PROJECT: Sheep Mountain Pkwy at Skyc Canyon

SUBMITTAL: 2nd

CITY OF LAS VEGAS INTER-OFFICE MEMORANDUM				DATE: June 20, 2018
TO: **Land Development Services** Department of Building & Safety				FROM: Albert Sung, P.E. Flood Control Project Engineer Department of Public Works
SUBJECT:	Drainage Study for: **Sheep Mountain Parkway at Skye Canyon**			**COPIES TO:** Slater Hanifan Group
Cross Streets:	Grand Teton Boulevard at Puli to Iron Mountain Road			M F Land LLC / Ninety-Five Management LLC
File Number:	F:\Depot\DSMemos\DS4952B.doc			Bart Anderson, P.E., DevCo
Parcel Number:	126-12-101-002			CCRFCD
Zoning Action:	N/A			
FEMA Flood Zone	YES	NO	X	
Proposed Storm Drain	YES	NO	X

Crossing - Lateral Profile #3 at SMP Sta 215+10, Design Discharge - 71.0 cfs

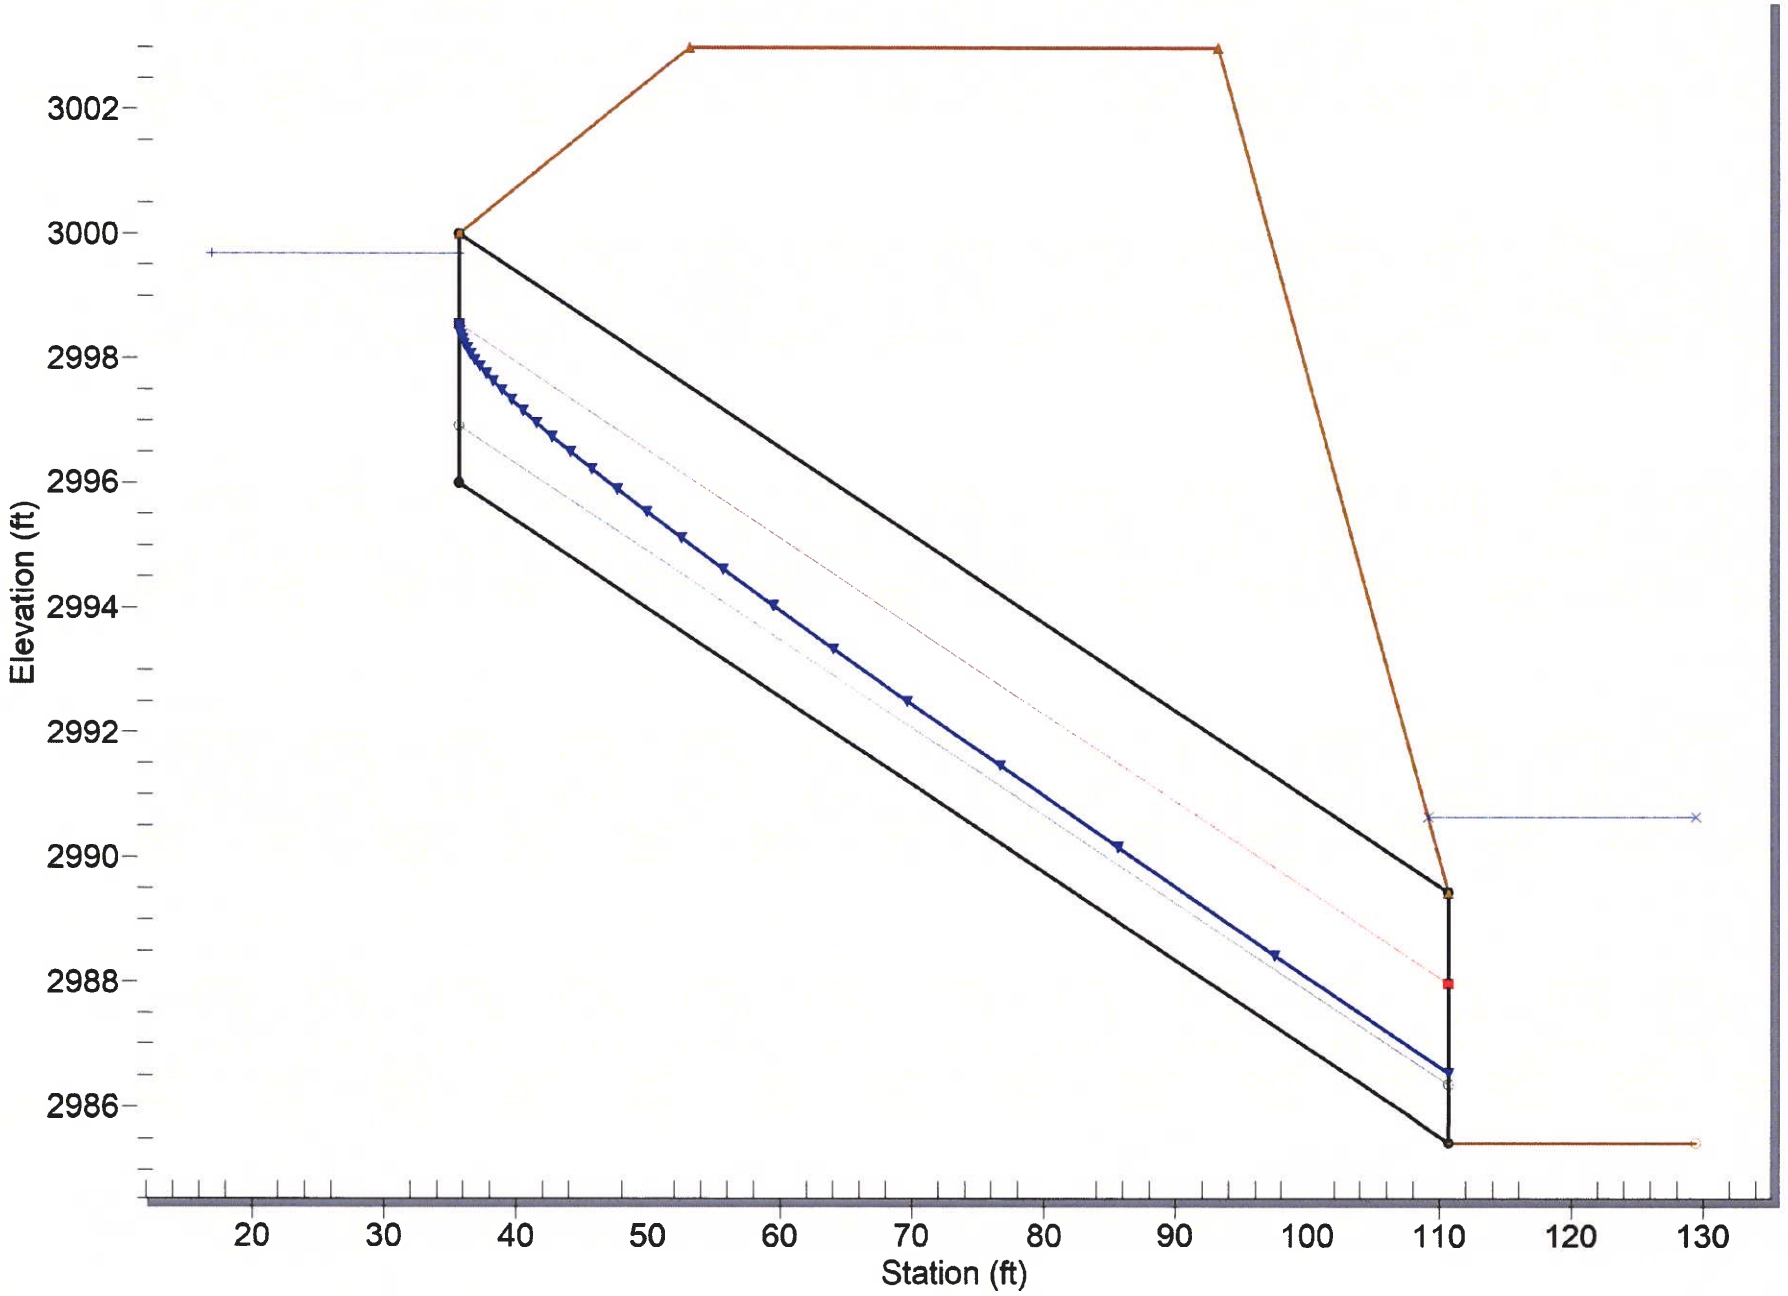
20. **Comment:** *Sheet GR-07: Construction Note #14 proposes CMP pipe which is not acceptable. Use RCP.*

Response: The 54-inch CMP culvert proposed on Sheet GR-07 has been revised to RCP. Due to the decrease in interior roughness in changing from corrugated metal to concrete, the hydraulic performance of the culvert has increased, and the size was able to be reduced to 48-inch. See Appendix C for revised HY-8 calculation.

C-01
SHEET 7 OF 50

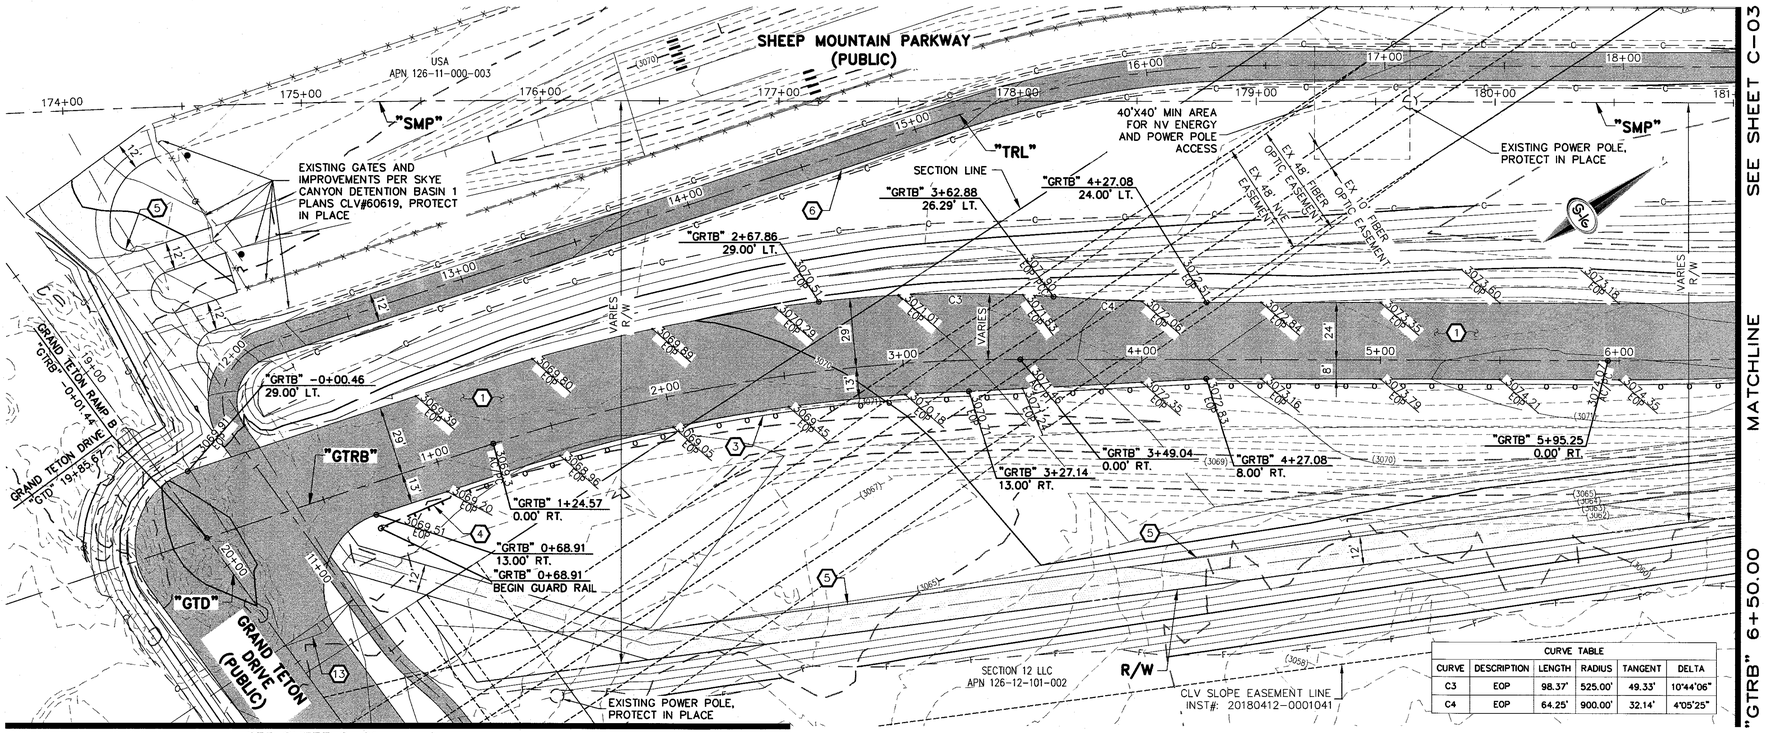
6. **Sheet C-01**: Construction Note #13 indicated relocating an existing gate but the plan didn't show where the new gate is. Also, a previous required "End of Road" marker was nowhere to be found on the plan. Review and revise accordingly.

Show and label existing concrete curb & gutter, sidewalk and amenity zone in the *Grand Teton Boulevard* right-of-way on the plan.

6. **Comment:** *Sheet C-01: Identify an existing gate for Kyle Canyon Detention Basin at the west end of Grand Teton Boulevard. Protect the gate in place and provide an access to the gate. Provide "End of Road" markers at the end of Grand Teton Boulevard. Provide access to Skye Canyon Detention Basin 1.*

C-06
SHEET 12 OF 50

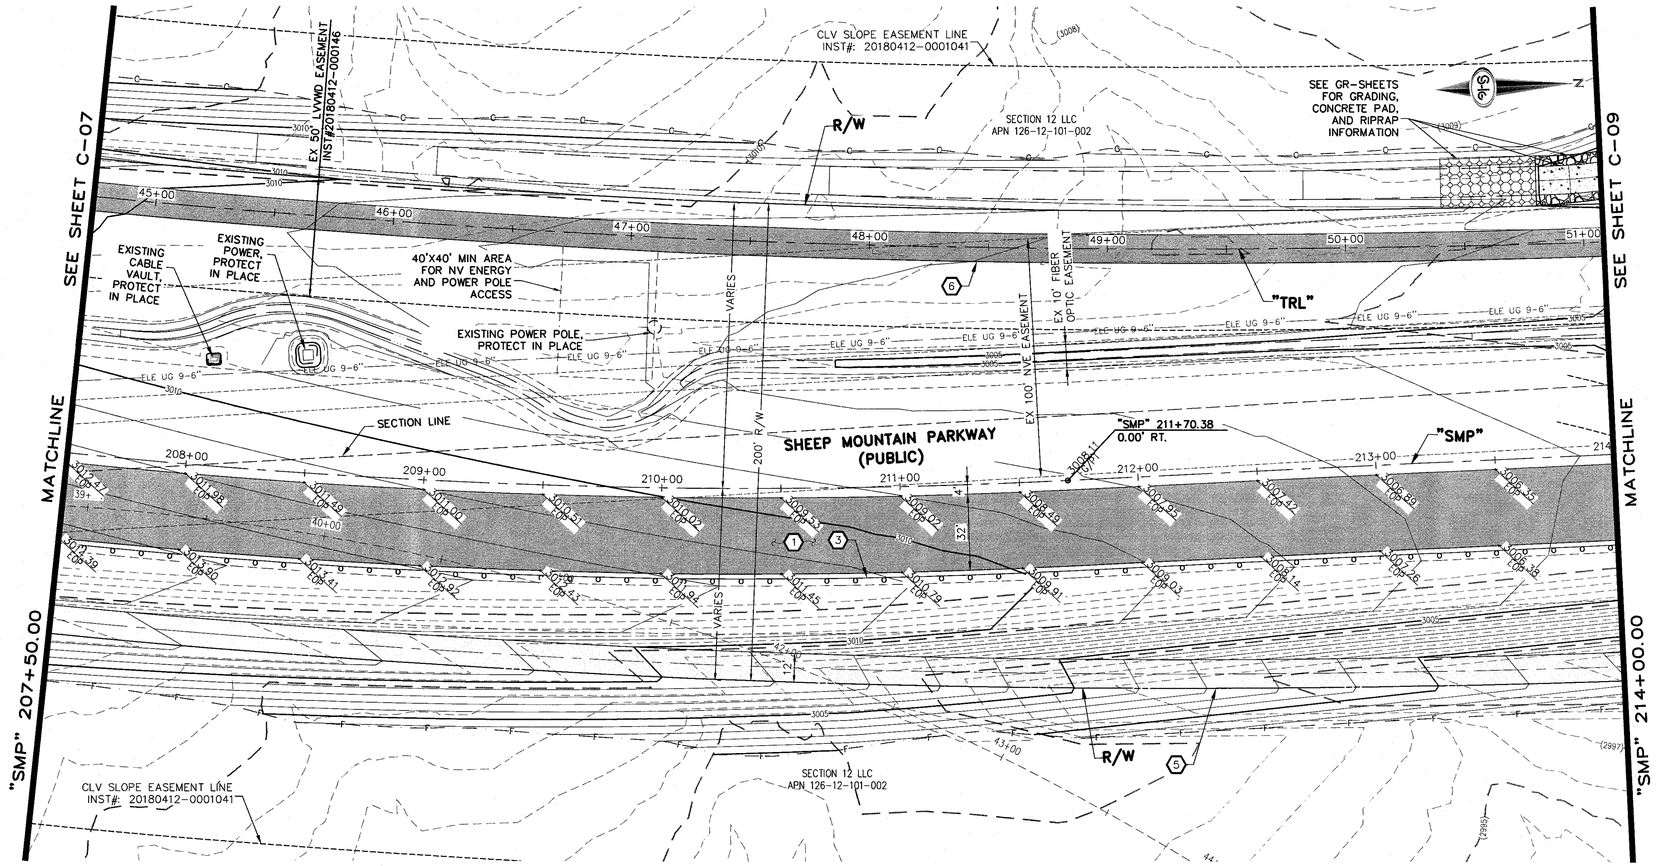
9. **Comment:** *Sheet C-06: Show and identify an existing Skye Canyon DB1 outfall facility on the plan.*

Response: Existing Skye Canyon DB1 outfall facility is shown and identified on Sheet C-06.

GR-01
SHEET 28 OF 50

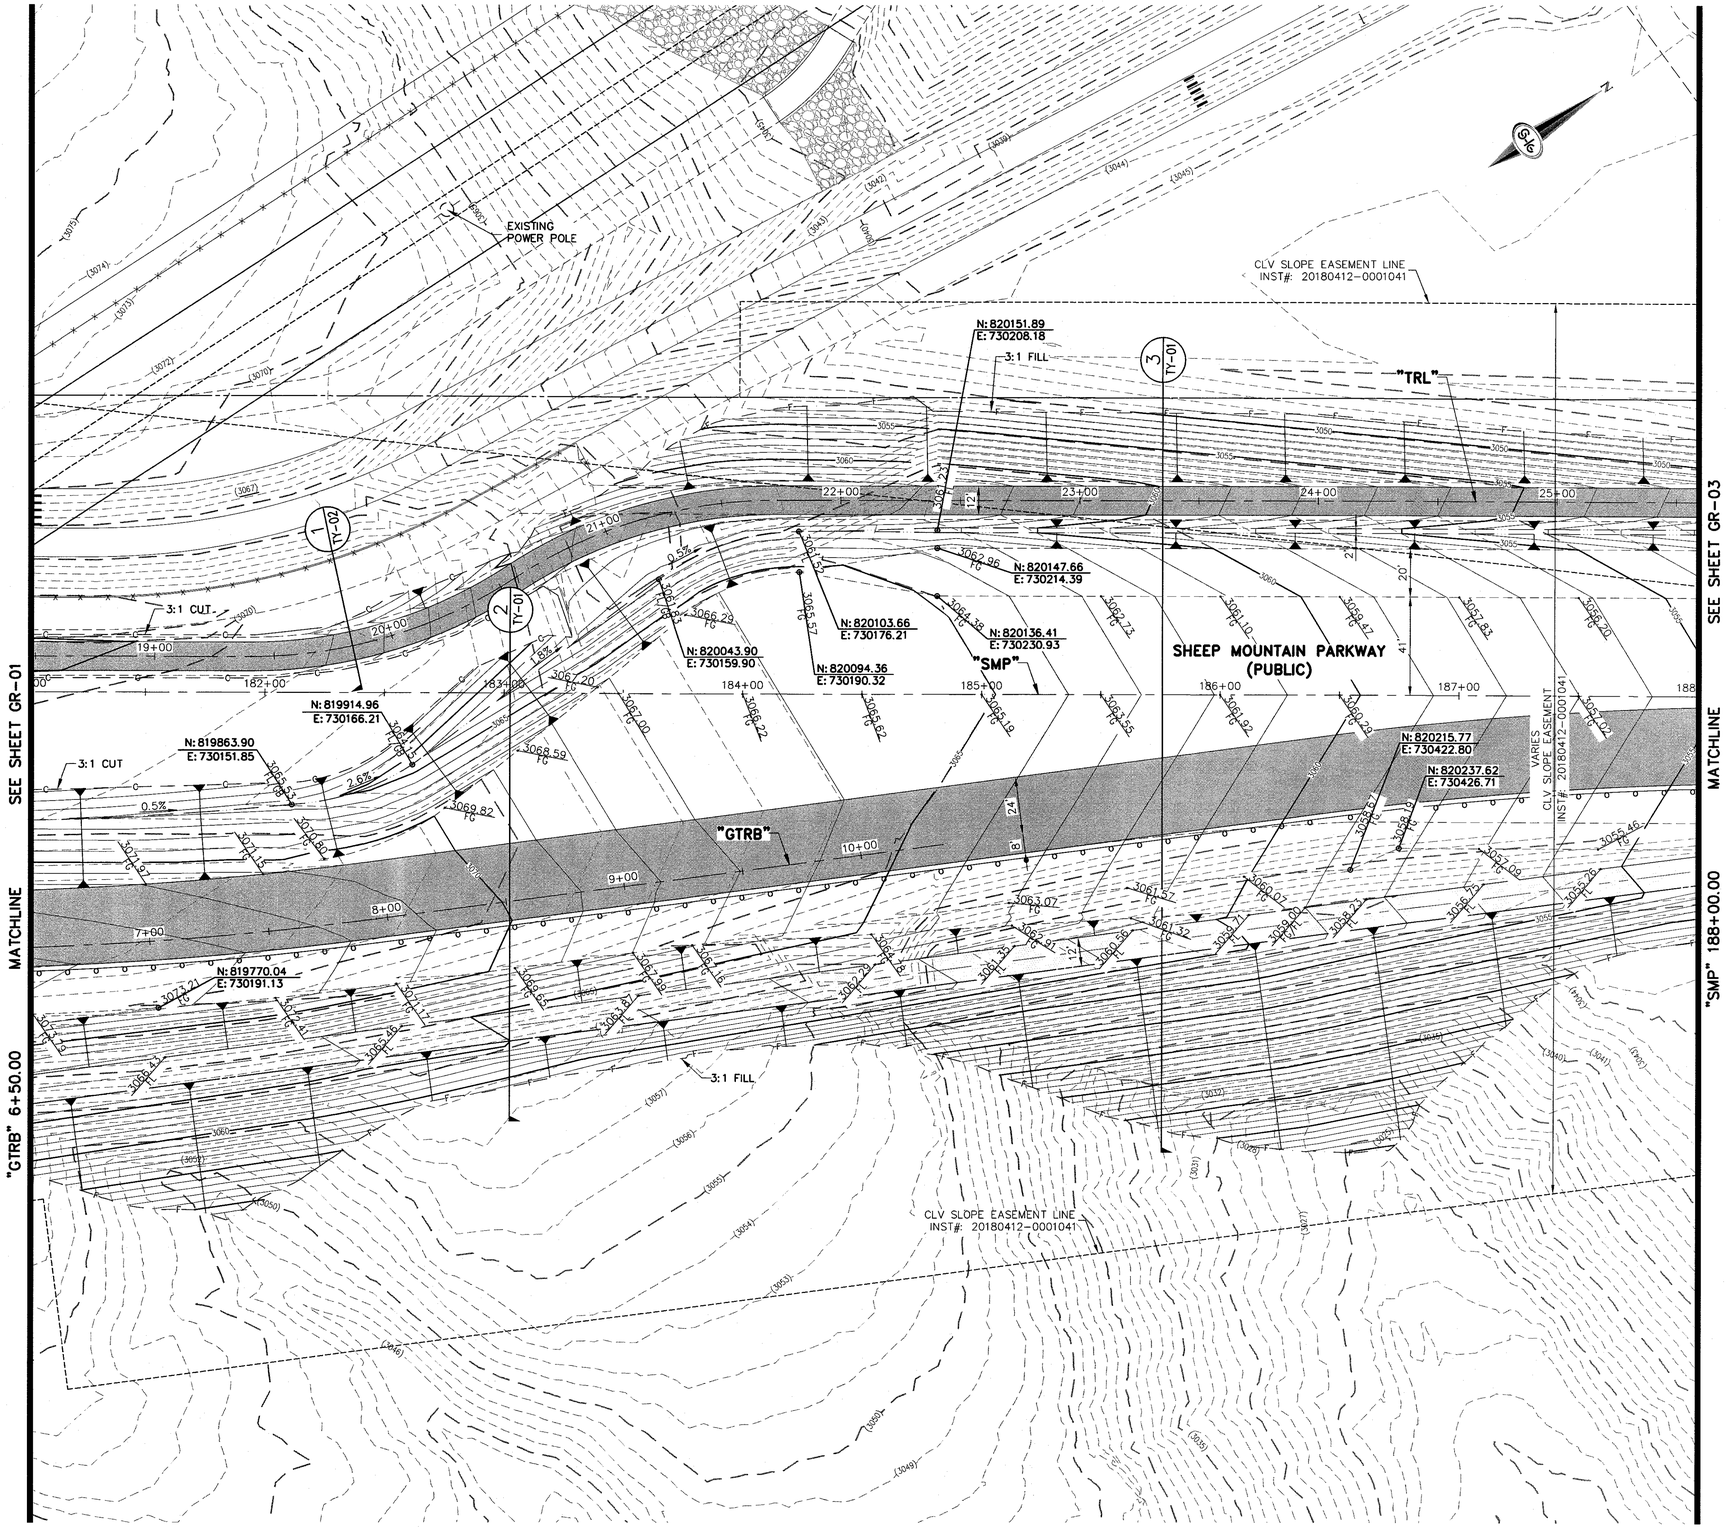
15. **Comment:** *Sheet GR-01: Detail Section 1/TY-01 shows swales on both sides of the paved **Sheep Mountain Parkway**. The plan shows flow line elevations at regular intervals on the west side of **Sheep Mountain Parkway**. However, there is no information of the swale on the east side of the roadway. Show flow line elevations accordingly in the next submittal.*

16. *Sheet GR-01: Detail Section 1/TY-02 shows ditches on both sides of the proposed trail. Show flow line elevations at regular intervals on both sides of the trail on the plan.*

GR-02
SHEET 29 OF 50

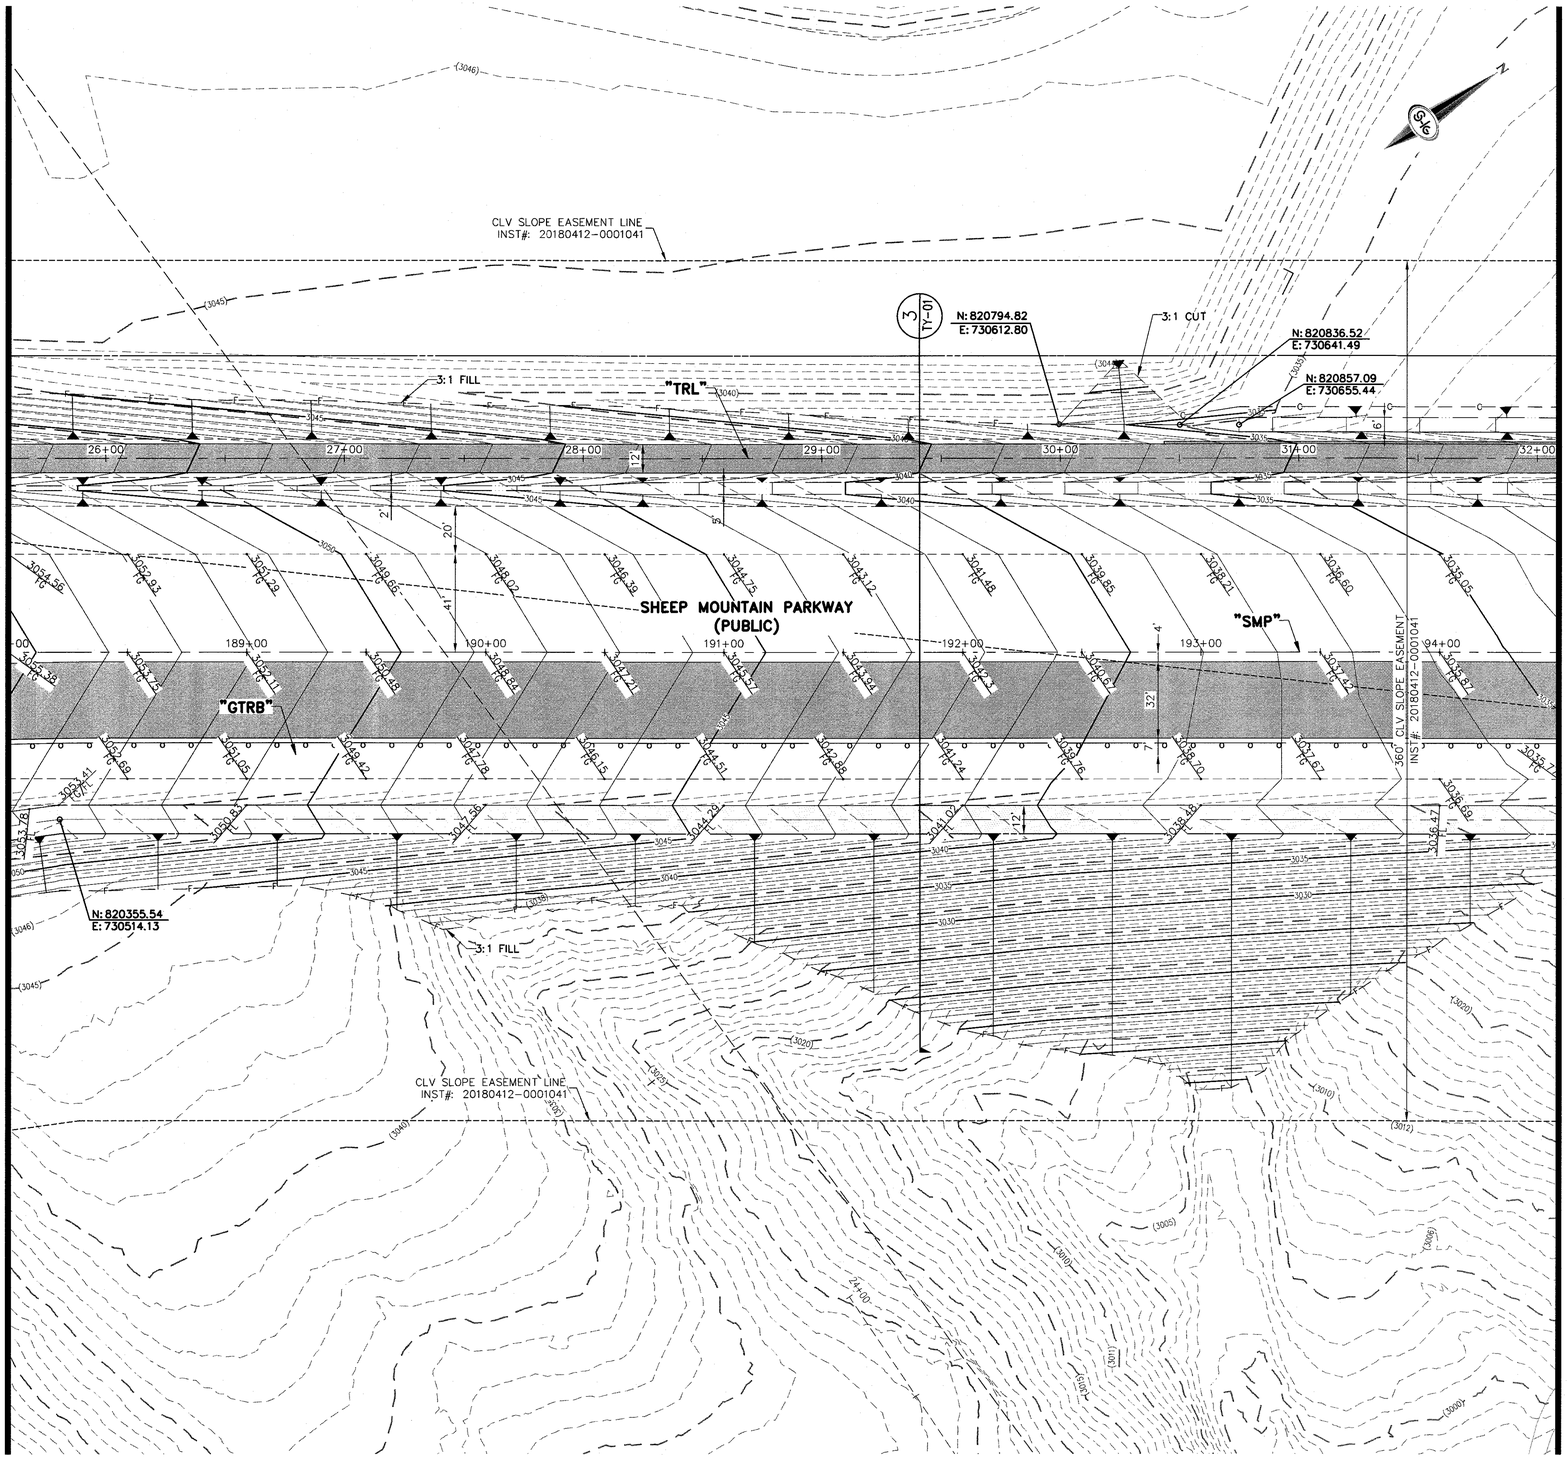
17. **Comment:** *Sheet GR-02: A notation line "----F is shown along the east ROW line which presumably means "fill" to the reviewer. However, a simple "fill" to the contractor without any grading design such as finished contours is not acceptable. Provide grading design in the next submittal. Note that the fill slope must not be greater than 2:1 or per the approved geotechnical report. Revise the plan and pertinent detail sections accordingly.*
